RECORD NO.: Plat-25-000091 (S245-235) **SENIOR PLANNER:** Sharmila Shrestha**LOCATION:** Parnell Street, southeast of Al Lipscomb Way**DATE FILED:** September 10, 2025**ZONING:** PD 595 (FWMU-3)**PD LINK:** <https://dallascityhall.com/departments/city-attorney/pages/articles-data.aspx?pd=595>**CITY COUNCIL DISTRICT:** 7**SIZE OF REQUEST:** 0.482-acres**APPLICANT/OWNER:** The Human Impact TX Land, LLC

REQUEST: An application to replat a 0.482-acre tract of land containing all of Lots 2, 3, and 4 in City Block 1/1115 to create one lot on property located on Parnell Street, southeast of Al Lipscomb Way.

PRELIMINARY REPLAT
LOT 2A, BLOCK 17115
LOTS 2, 3 & 4, BLOCK 17115
PANEL TERRACE
MACMILLAN SURVEY
CITY PLAN FILE NO. S245-235
ENGINEERING PLAN NO. DP-17
PLAT 25-000091
CITY OF DALLAS, DALLAS COUNTY, TEXAS

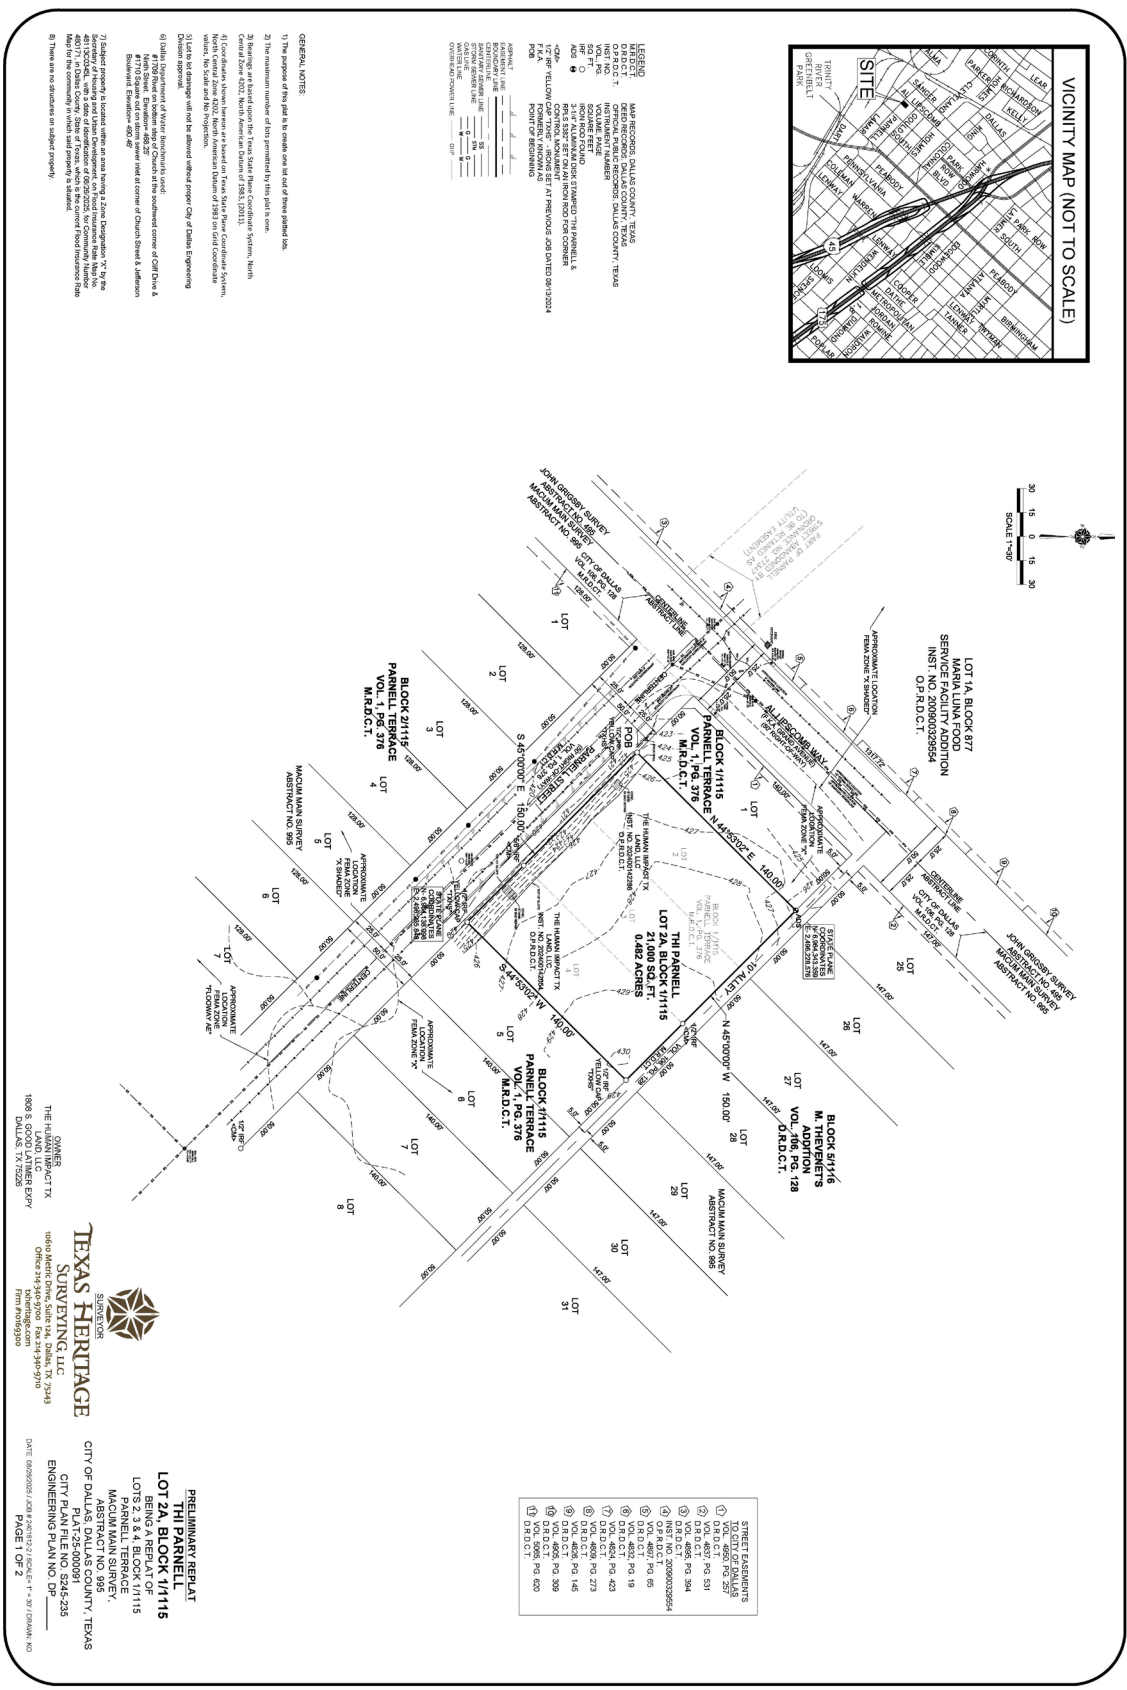
12. Submit drainage, paving, etc. plans prepared by a licensed (TX) Professional Engineer to Permit Center, Oak Cliff Municipal Center (i.e., non-311T/DP).51A-8.102 (c); 8.601(b)(4), (5), (6),(7),(8),(9)
13. Place a note on the final plat stating "Lot-to-Lot drainage will not be allowed without proper City of Dallas Engineering Division approval" 51A 8.611(e)

14. On the final plat, dedicate 7.5 feet of right-of-way (via fee simple) from the established center line of the alley. Section 51A 8.602(c)
15. On the final plat, dedicate 28 feet of right-of-way (via fee simple or street easement) from established center line of Parnell Street. Section 51A 8.602(c); 51A 8.604(c)

17. Additional design information is required for assessment. Site plan must be submitted showing proposed development, building finished floor elevation, development, existing mains – including downstream manhole, and proposed water and wastewater service locations. Submit water/wastewater engineering plans to 320 E. Jefferson Blvd., Room 200, Attention: Water and Wastewater Engineering.

18. Tree survey required prior to Arborist approval of the plat. Non-permitted tree removal occurred on this property and must be acknowledged and resolved. Tree surveys must show trees previously removed as well as trees still standing.
19. On the final plat, identify the property as Lot 2A in City Block 1/1115.
